Item ID: D119-646-241

Item Name: Replacement Skidtube STD w/ Training Wearplates

DRAWING NO. D3887	TITLE A119 STD SKIDTUBE ASSY	REV. B	DART AEROSPACE LTD ENGINEERING ORDER		D.E.O. NO. D3887-B-1	SHEET NO. SHEET 1 OF 1	SCALE NTS
DRAWN AJS		CHECKED <i>qp</i>	MFG. APPR. <i>ad</i>		APPROVED <i>ad</i>	DE APPR. <i>ad</i>	
DATE 12.10.29		DATE 12.10.29	DATE 12.10.30		DATE 12.10.30	DATE 12.10.30

MODIFICATION OF EXISTING DESIGN TO ALLOW INSTALLATION OF CROSSBOLT SPACERS FOR FORWARD GROUND HANDLING EQUIPMENT.

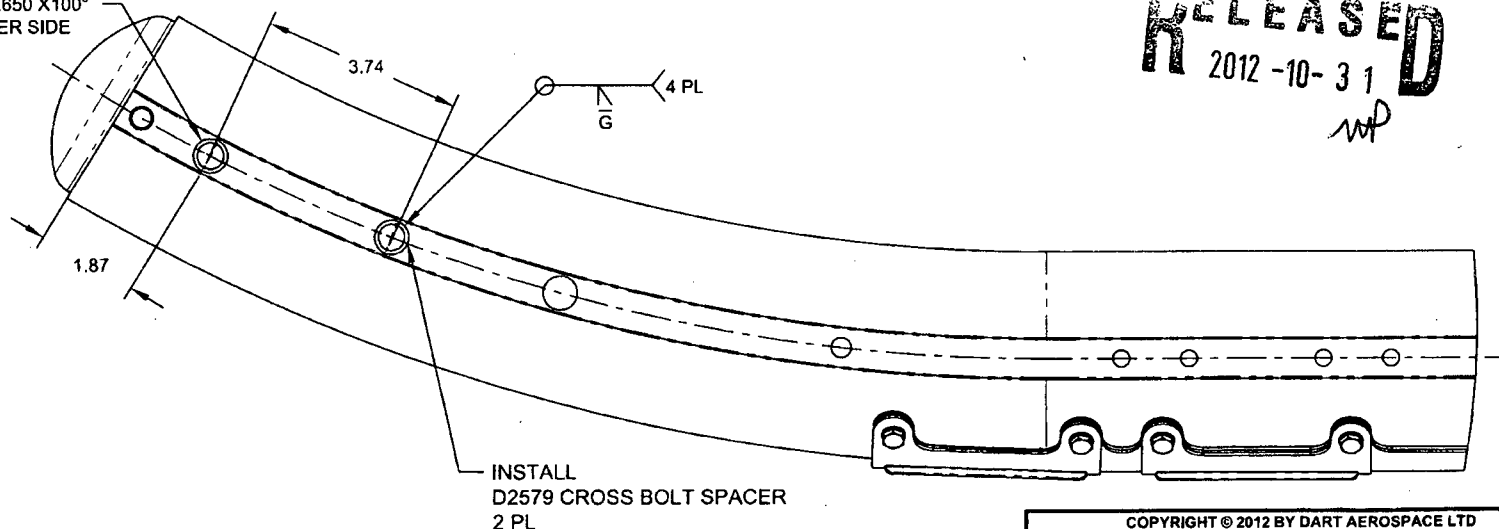
ADD THE DRILLING DETAIL BELOW TO DRILLING INFORMATION (SHEETS 5 & 6):

ADD CROSSBOLT SPACER INSTALLATION INFORMATION TO -041 THRU -045 (SHEETS 2 - 4):

DRILL Ø0.500 THRU
CSK Ø0.650 X100°
2 PL PER SIDE
